2017SSH038 – 945-947 Old Princes Highway &
2-4 Anzac Avenue, Engadine

DA17/1307

ASSESSMENT REPORT APPENDICES

DRAFT CONDITIONS OF CONSENT
Development Application No. 17/1307

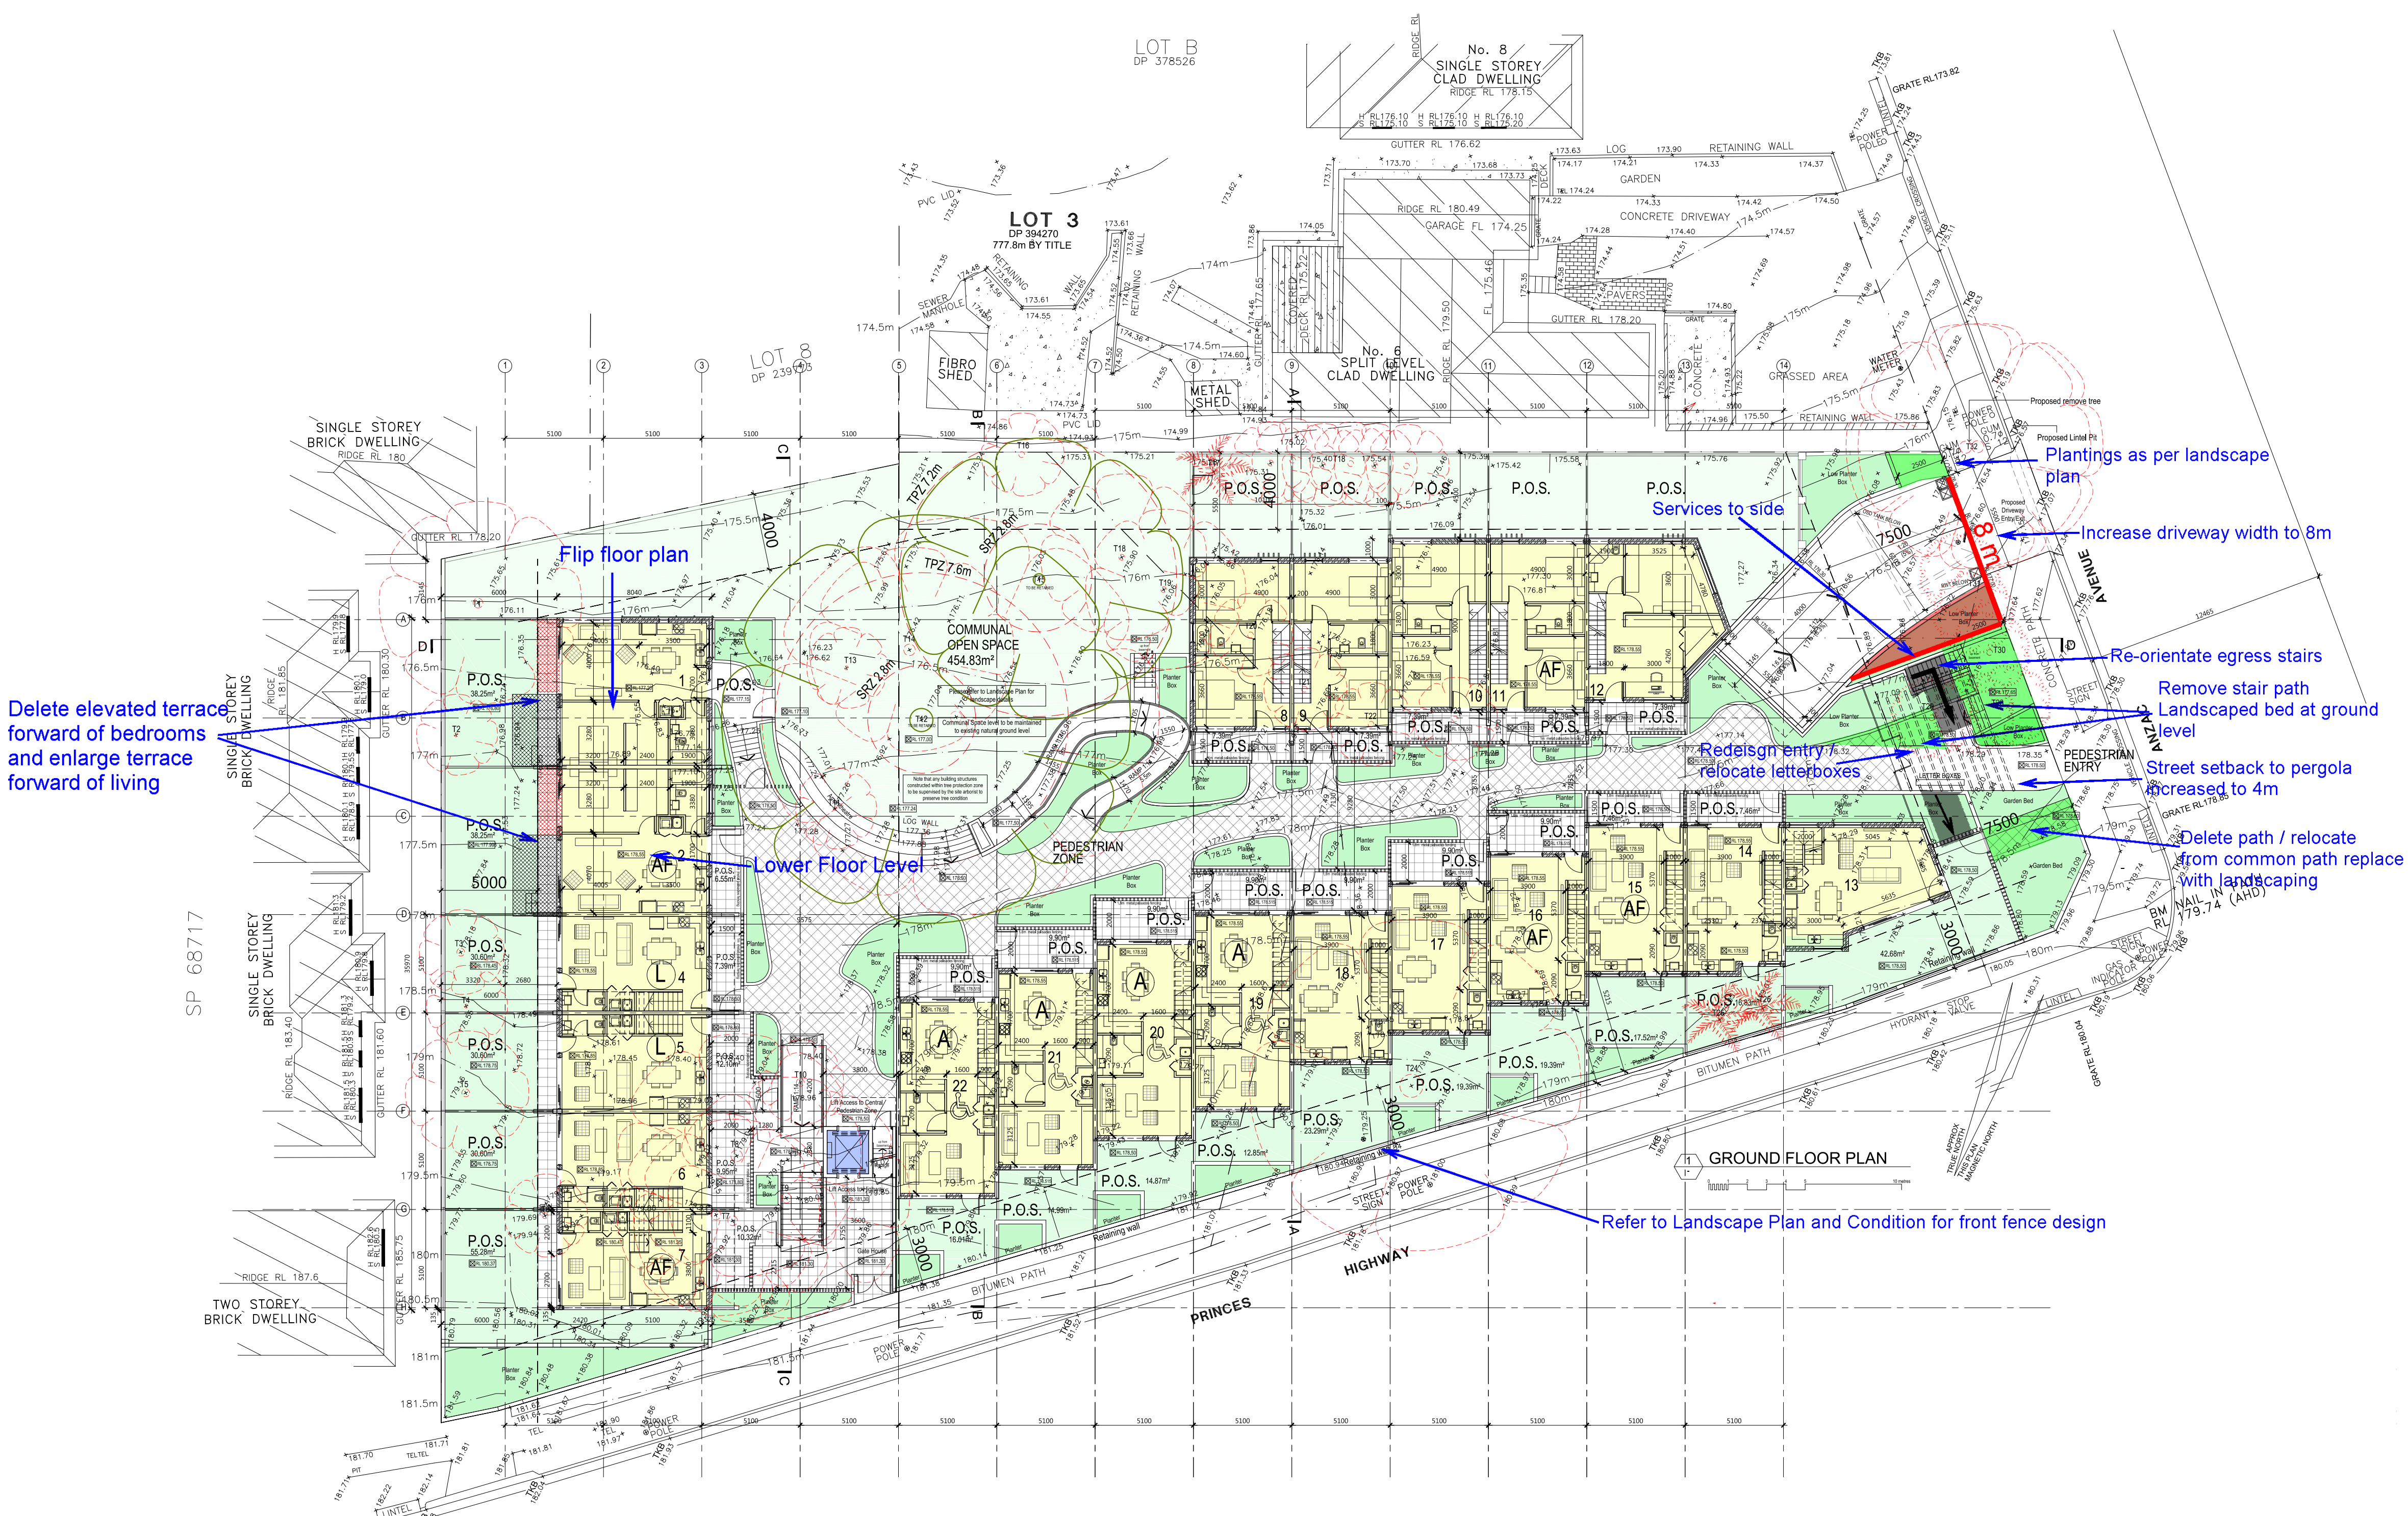
Similarly, townhouses 3 and 4 could have a grouping of more pronounced balconies at first floor level to differentiate their central location, to provide a feature at the end of the pedestrian zone, and to increase the sense of surveillance.

All elevations need to be shown, including elevations to the pedestrian zone.

DA-02.1

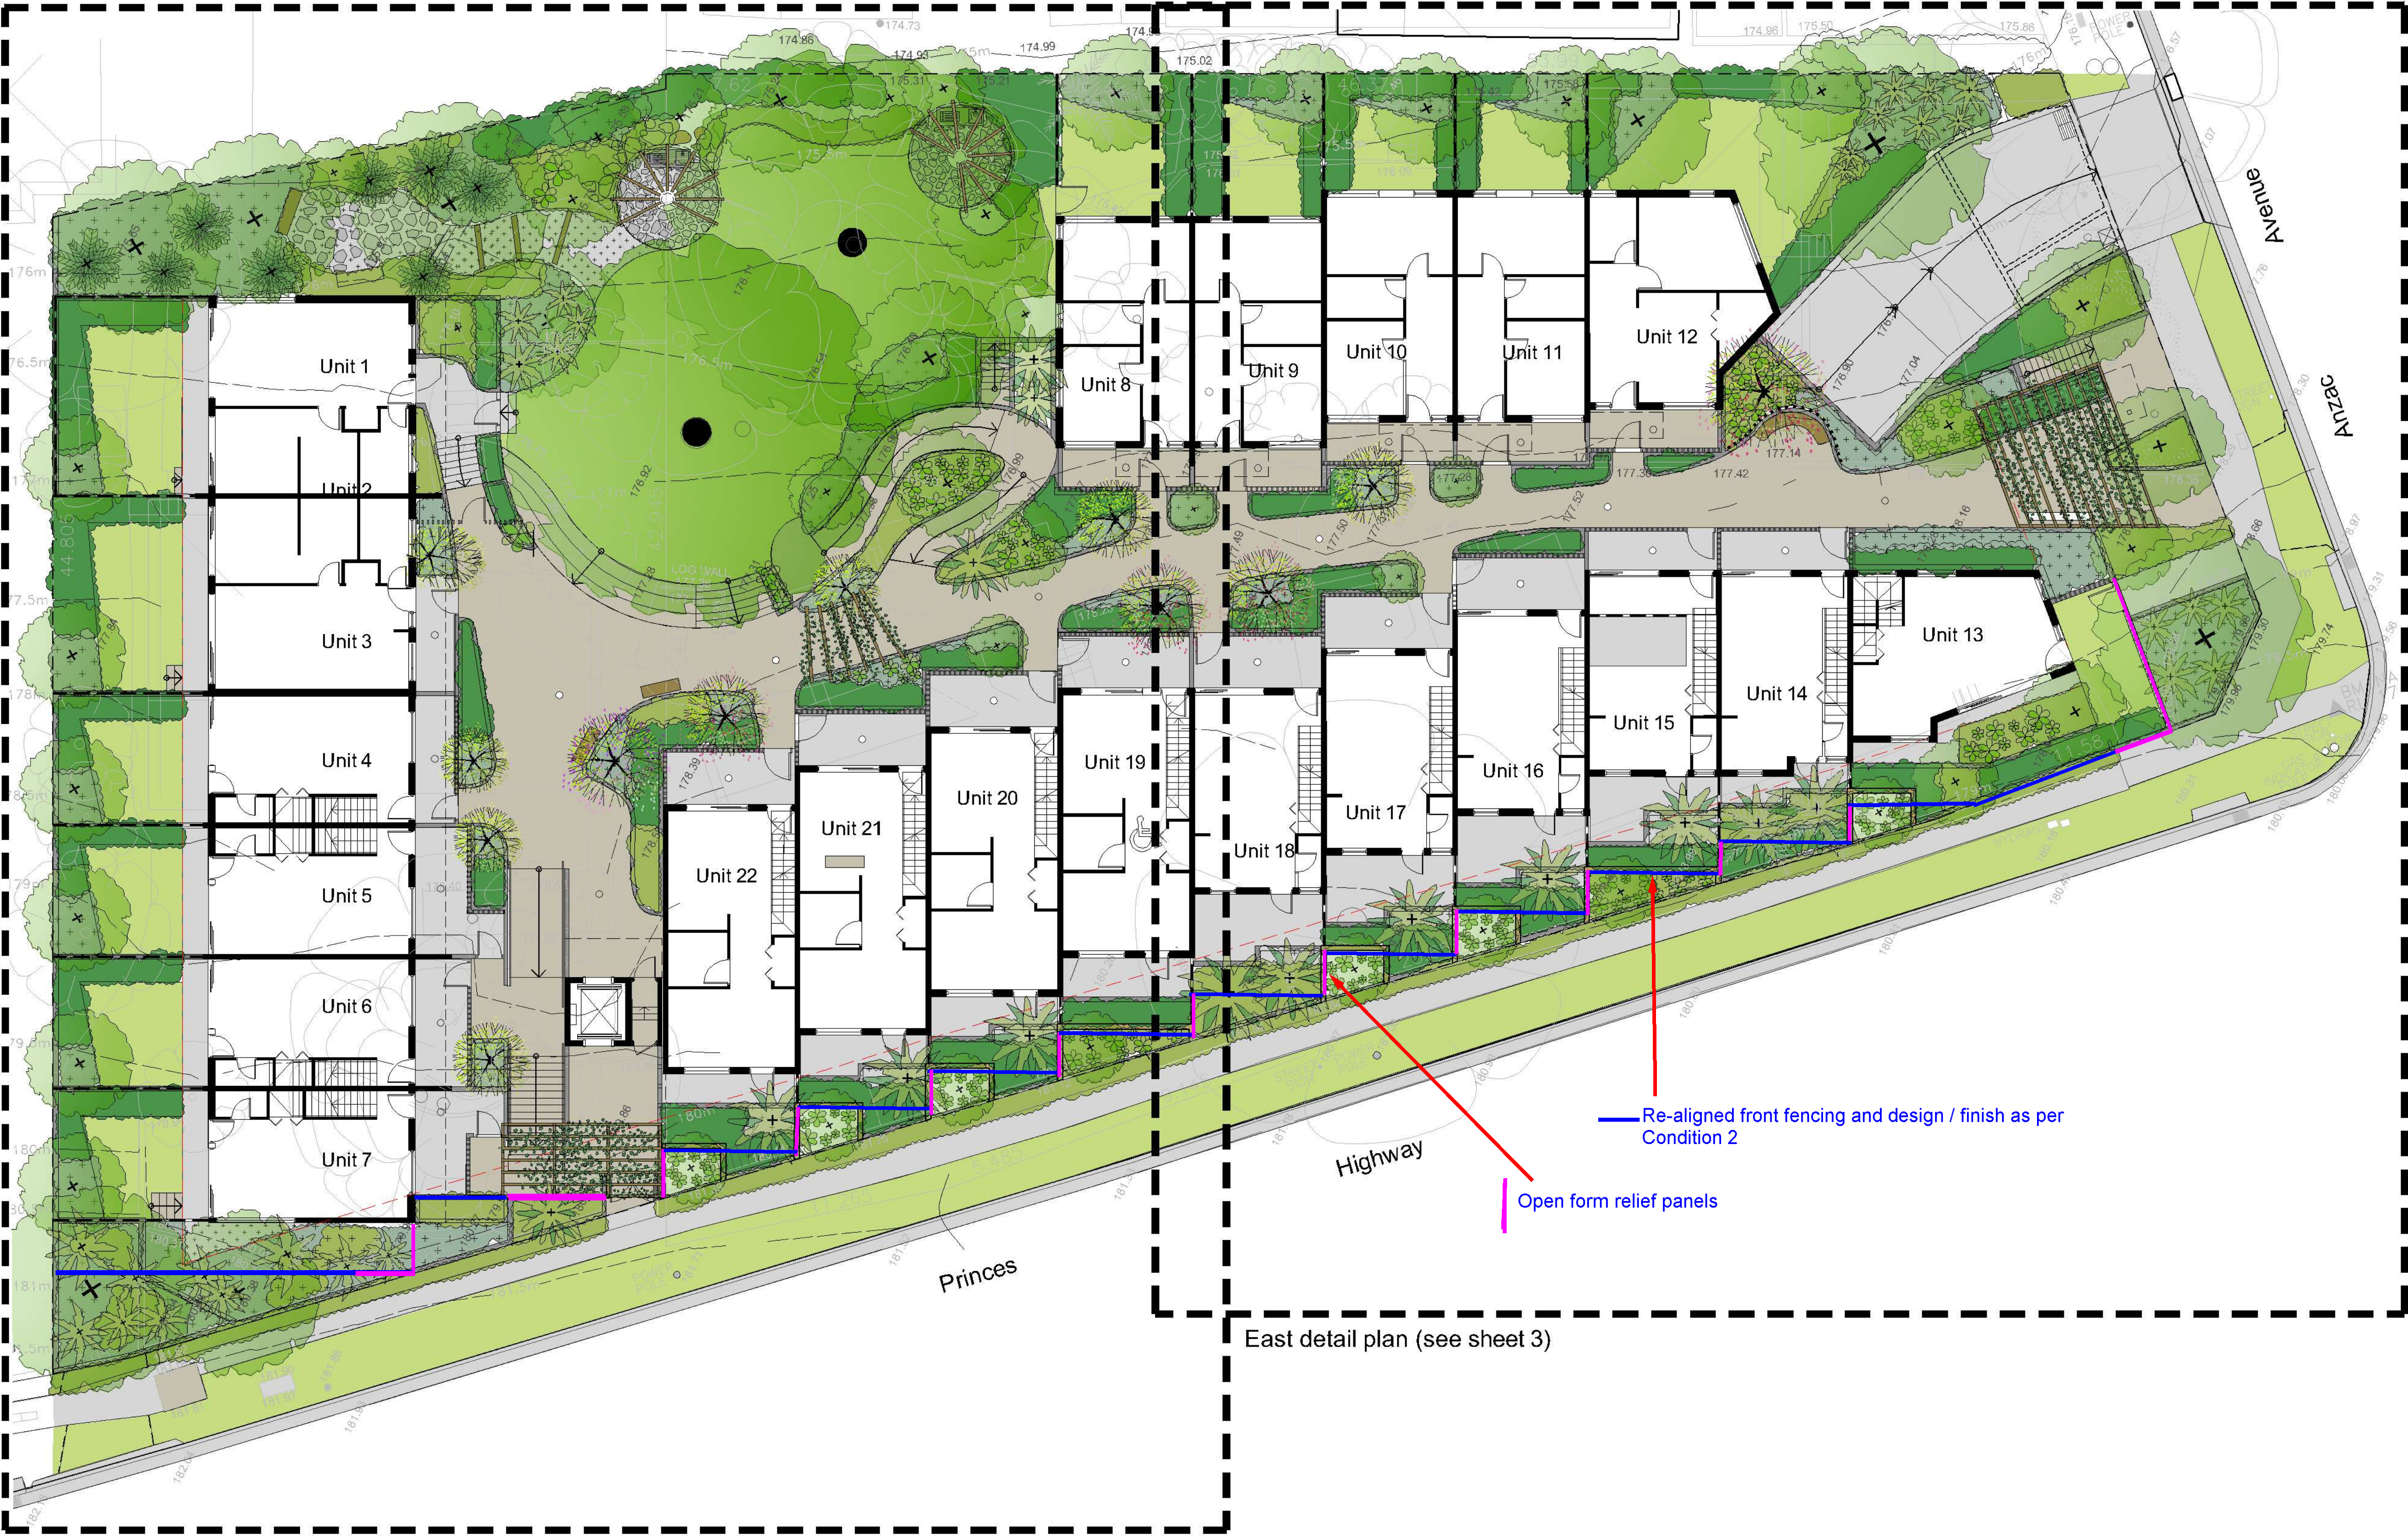
- i. The basement egress stairs to the Anzac Avenue frontage shall be re-orientated to turn and exit in a southerly direction adjoining the common level entry path of the development. The common entry stair adjoining the level entry path shall be deleted and replaced with planted landscaped area. All garden beds within the sites frontage shall be maintained at ground level to maintain site lines for

- ii. An 8m wide vehicular crossing shall be constructed. To achieve this, the driveway shall be widened in a southerly direction towards the common entry path.
